Bentley Bulletin

20-059

Subject: Safety Recall – Fuel Line Quick Connector (RE20/14)

Topic	Bentayga 4.0 L V8 TSI - Engine control module and fuel hose check (RE20/14)
Market area	Bentley: worldwide (2WBE)
Brand	Bentley
Transaction No.	2054018/1
Campaign number	RB56
Note	
Type	
US code

Figure 2

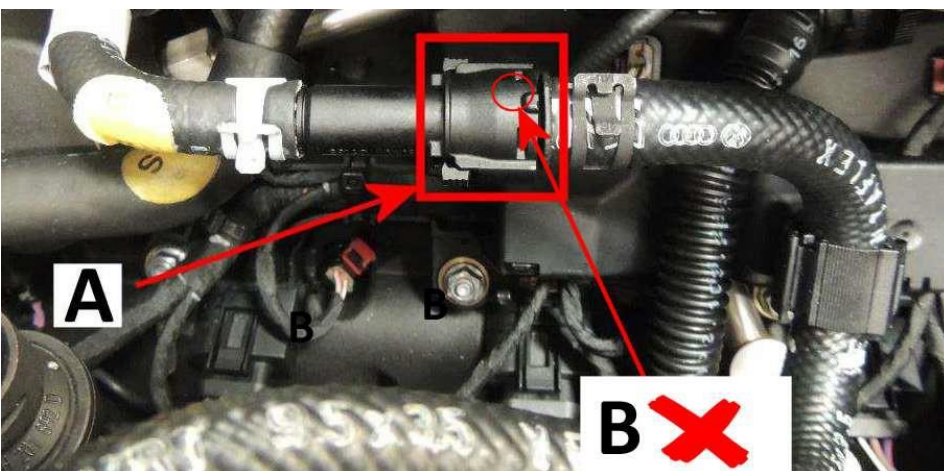
2) Referring to Figure 2 (Incorrect orientation) - Locate the connection at (Point A)

Visually check the connection shown at (Point B) should no hole or dimple be evident (facing upwards) this shows an incorrectly orientated hose and MUST be replaced

- **VERY IMPORTANT:** In the event the hose orientation is confirmed as incorrect the hose **MUST BE REPLACED DO NOT ATTEMPT** to rotate the hose/quick connect – Refer to the fuel hose replacement instructions within the onward instructions

Figure 3

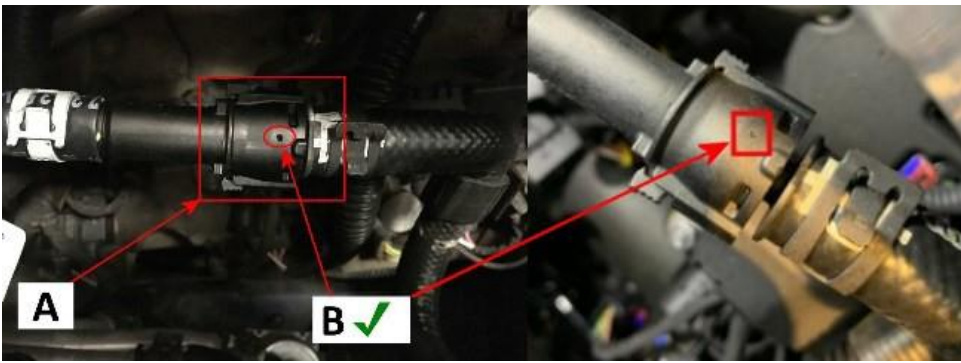
3) Referring to the example shown in Figures 3 (Correct orientation) - Locate the connection at (Point A)

• Visually check the connection shown at (Point B) should the hole/dimple be evident (MUST be facing upwards) this shows a correctly orientated hose

IMPORTANT NOTE: The holes/dimples can vary in depth/size as can be seen in the two examples shown at (Point B)

VERY IMPORTANT: Although correctly orientated, the hose MUST be replaced if the software update is required to be updated

Figure 4

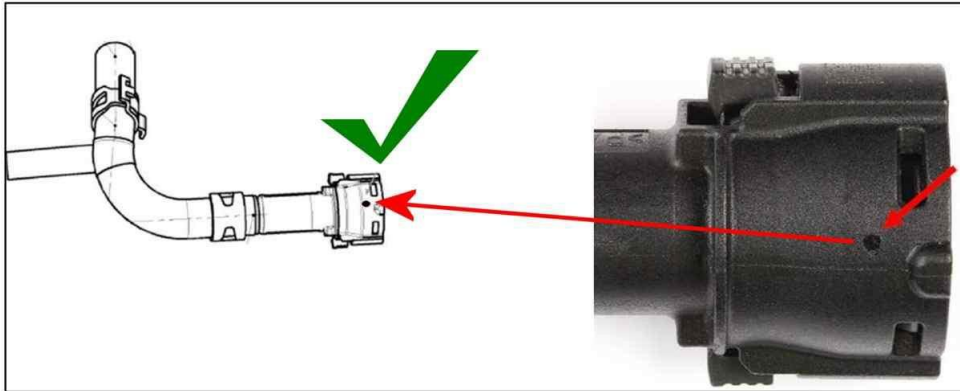
- Figure 4 also shows a close up example of a correctly orientated hose (see hole/dimple which is facing upwards)

Figure 3

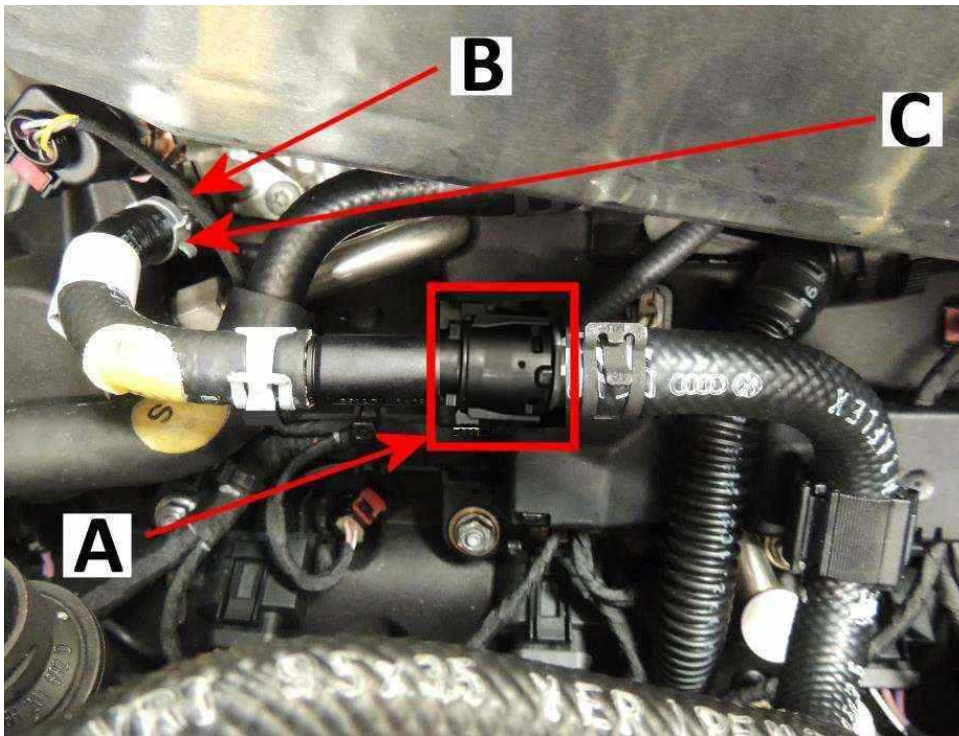
4) Referring to Figure 3 - Install the new hose (06M 133 986S) as follows:

Connect the quick connector (Figure 3 Point A) Ensure the latch is fully located/locked - Refer to Repair manual Rep.Gr 20 "Special instructions for fuel system quick connectors" carry out all instructions as per Repair manual instructions you must ensure all instructions within the Repair manual instructions are strictly adhered to

CAUTION Carry out a pull test to confirm correct fitment of the quick connect (Figure 3 - Point A) - Do not rely on an audible click to confirm that a secure connection has been made

- Ensure the orientation of the harness is as shown in (Figure 3 - Point B)
- Referring to (Figure 3 - Point C) - Install the hose onto the metal pipe - Use Hose clip pliers - ASE45149200000 fit the spring band clip

Figure 4

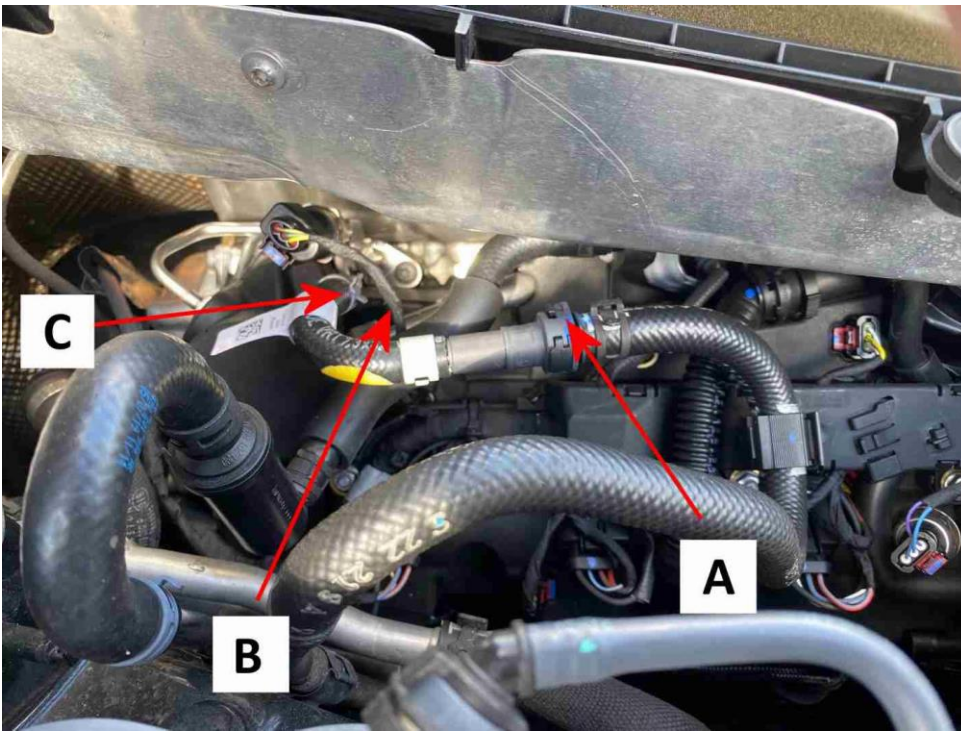
5) Referring to Figure 4 - Install the new hose (0P2 133 986C) as follows:

- Connect the quick connector (Figure 4 Point A) - Refer to Repair manual Rep.Gr 20 "Special instructions for fuel system quick connectors" carry out all instructions as per Repair manual instructions you must ensure all instructions within the Repair manual instructions are strictly adhered to

CAUTION Carry out a pull test to confirm correct fitment of the quick connect (Figure 4 - Point A) - Do not rely on an audible click to confirm that a secure connection has been made

- Ensure the orientation of the harness is as shown in (Figure 4 - Point B)
- Referring to Figure 4 - Point C) - Install the hose onto the metal pipe - Use Hose clip pliers - ASE4514920000 fit the spring band clip
- Check and confirm the latch shown in Figure 5 is fully closed/located in the direction shown (Arrow)

Figure 6

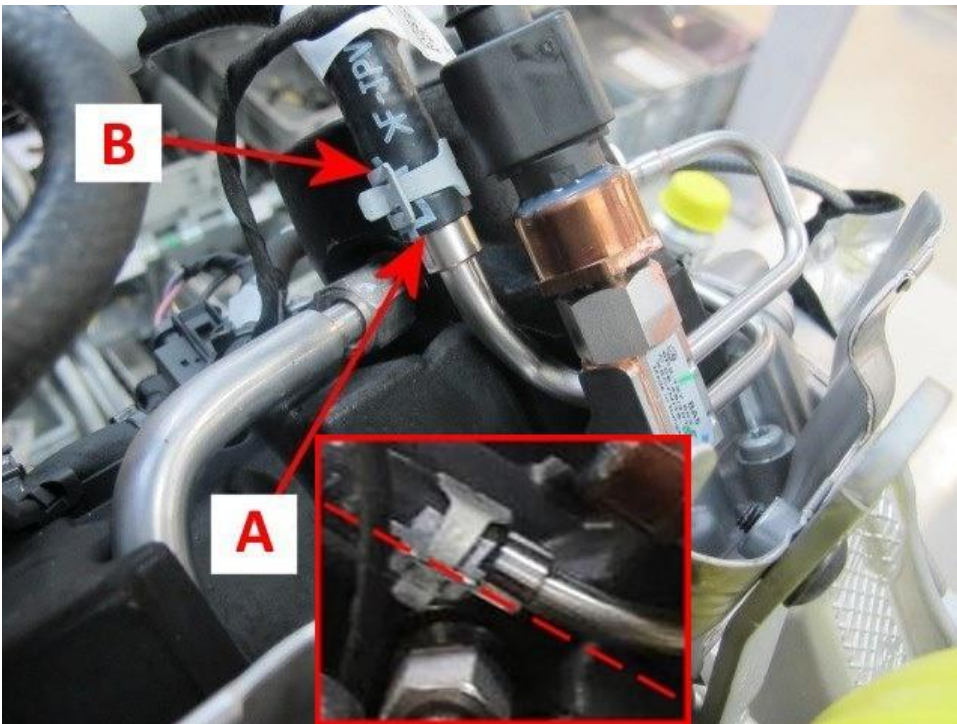
6) **IMPORTANT:** Referring to Figure 6 - Ensure the hose is fully fitted up to the boss on the metal pipe (Point A)

- Ensure the timing mark on the fuel hose is lined up with the timing mark as shown (Inset)
- Ensure the clip is located exactly as shown (Point B)
